# **Addendum to Appendix D**

## **Technical Alignment Report**

*Prepared by*  
Alaska Department of Transportation and Public Facilities  
6860 Glacier Highway  
Juneau, Alaska 99801-7999

This addendum outlines changes to the design criteria, updates the alignment discussion where changes have occurred, provides updated bridge summaries, provides updated plan and profile sheets where changes have occurred, updates ferry terminal layouts and cost estimates, updates the Engineer's Estimate, and provides an errata sheet for the original technical report.

FIGURE  
3-1

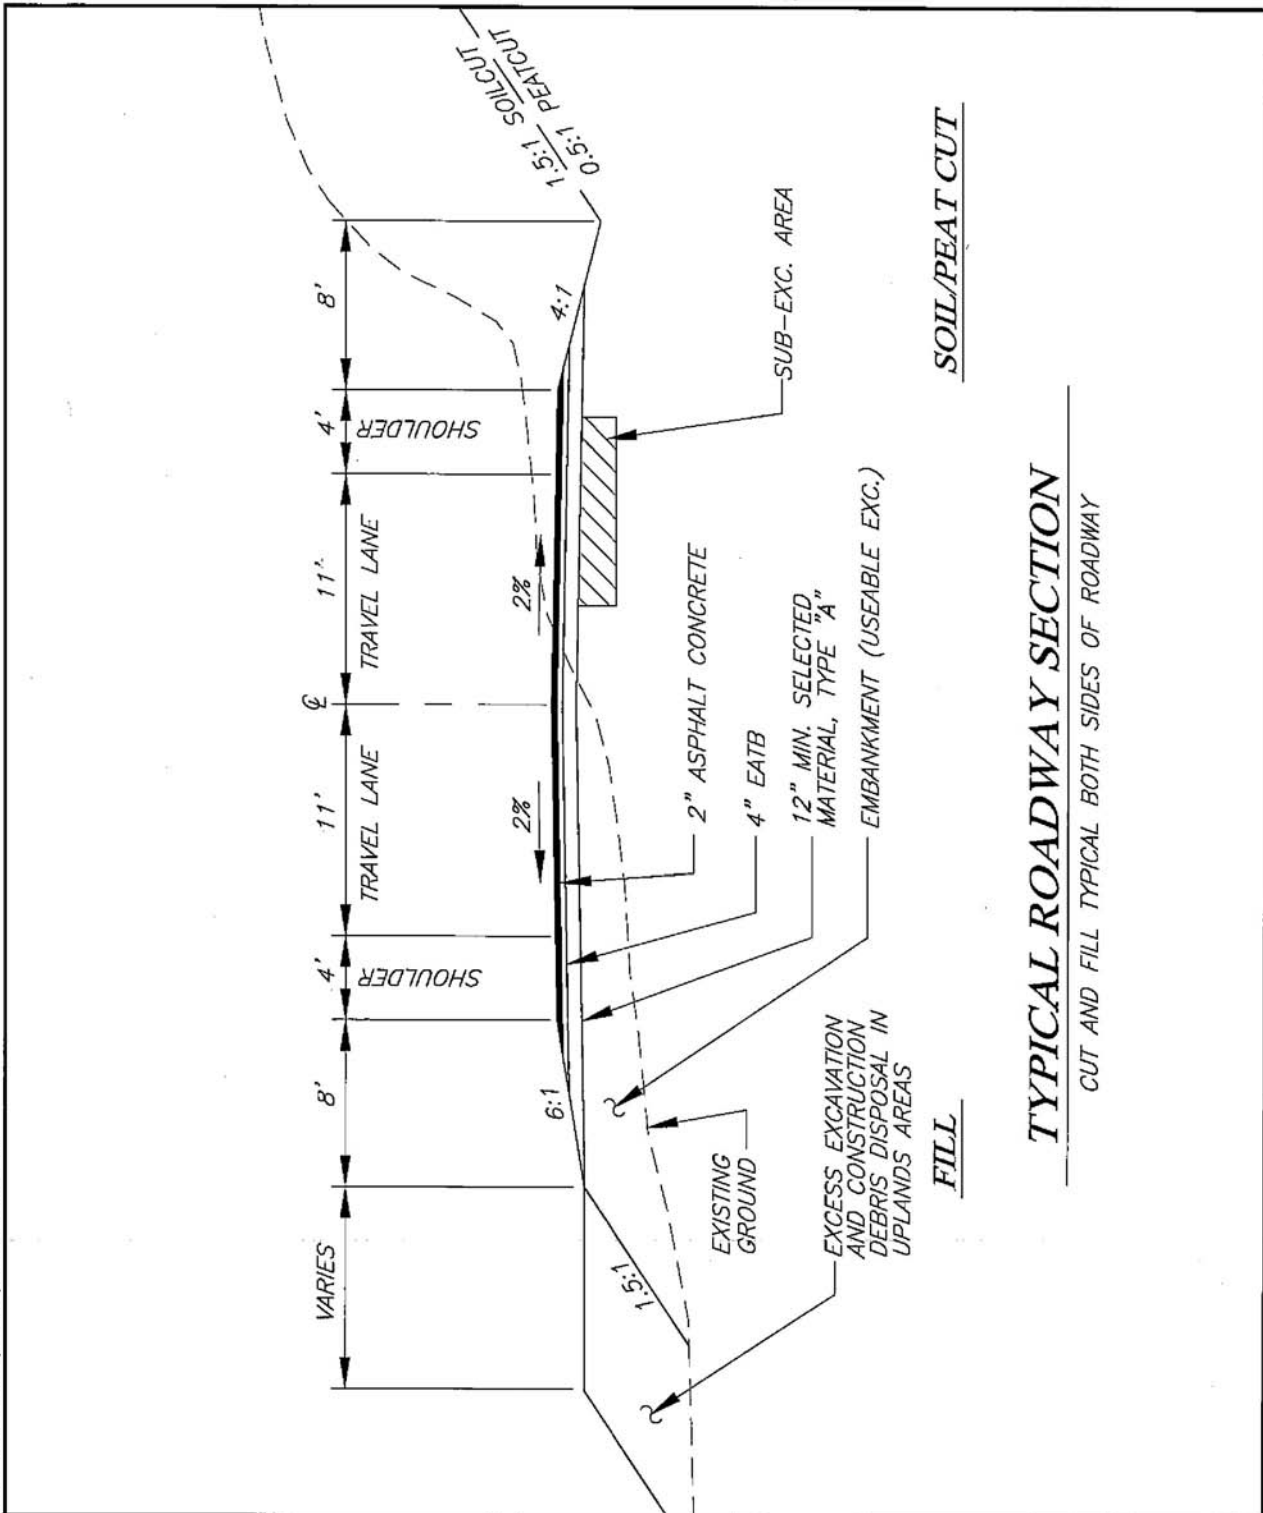
The highway typical section has been revised to replace the 6-inch-thick layer of Base Course with a 4-inch-thick layer of Emulsified Asphalt Treated Base (EATB). The EATB will provide a more durable Structural section. The EATB was included in the Supplemental Draft EIS Engineer's Estimates for all alternatives, but was not correctly shown on the typical sections.

The attached Figures 3-1 through 3-6 and 3-8 reflect this change.

FIGURE  
 3-8

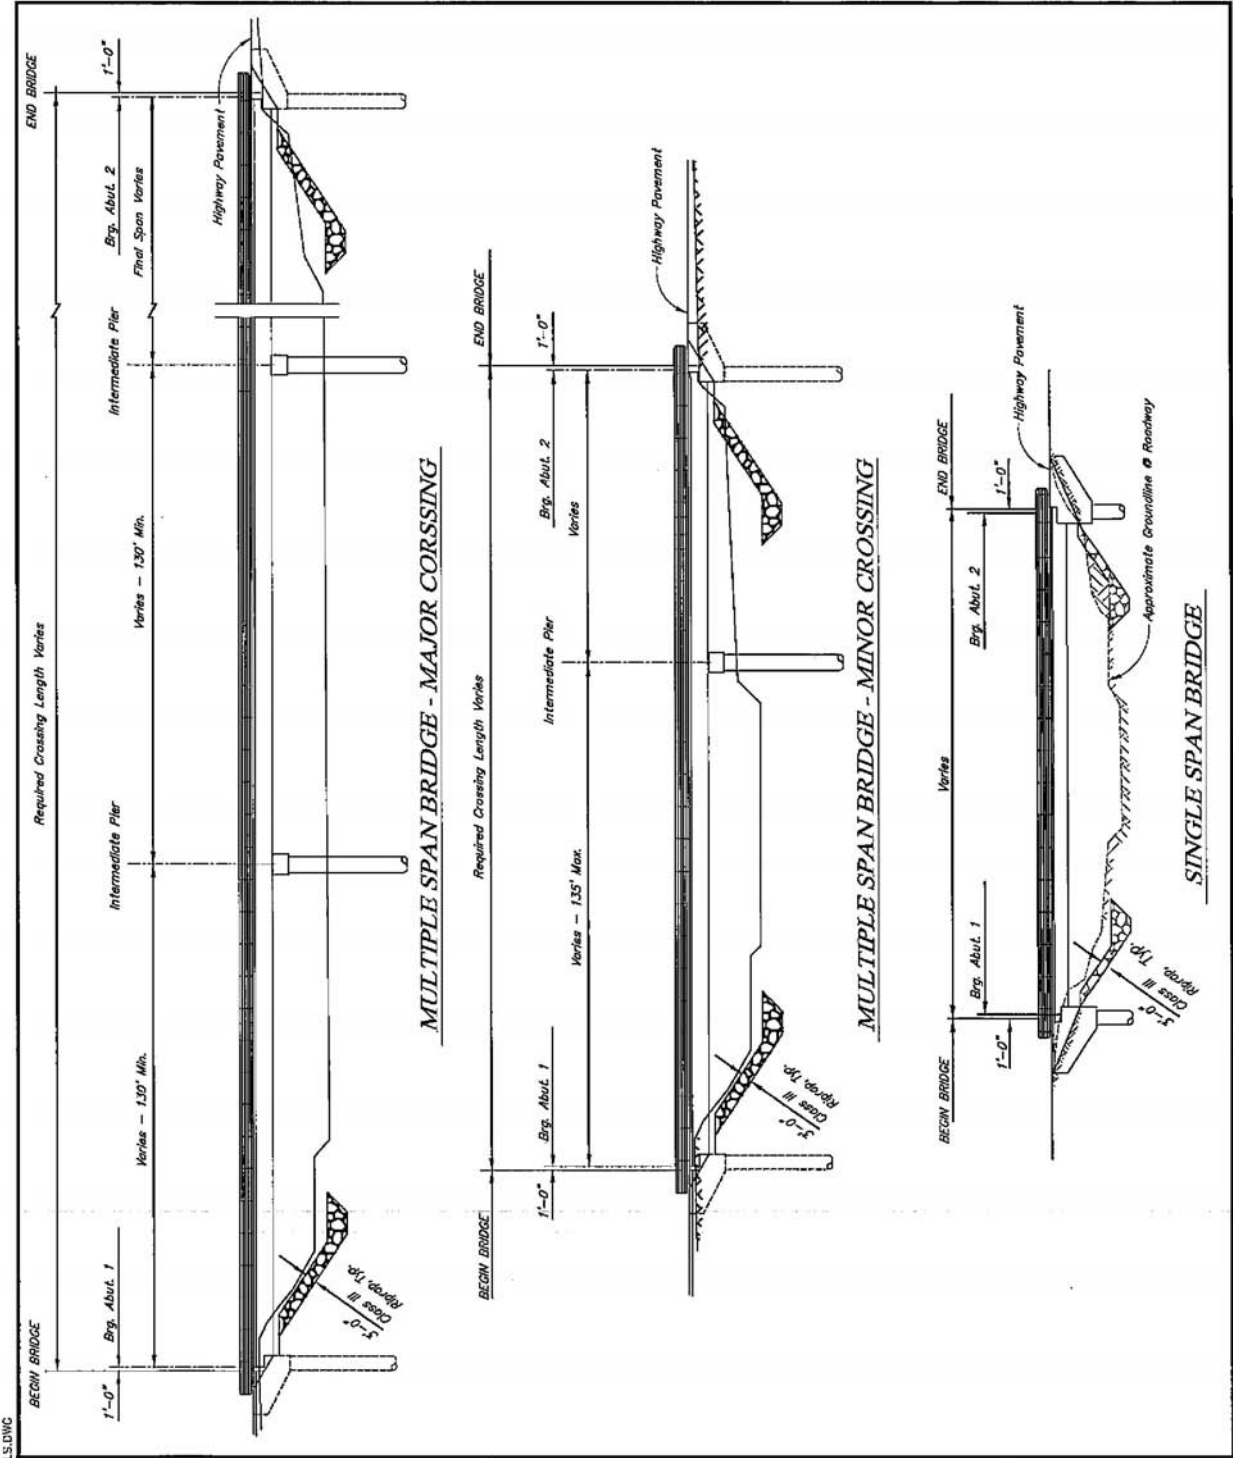
Figure 3-8, “Bridge Elevations,” has been updated to distinguish between Multiple Span Bridges for Major and Minor Crossings. Figure 3-7, “Bridge Typical Section,” from the 2004 Supplemental Draft EIS *Appendix O Technical Alignment Report* remained unchanged and is therefore not included in this addendum.
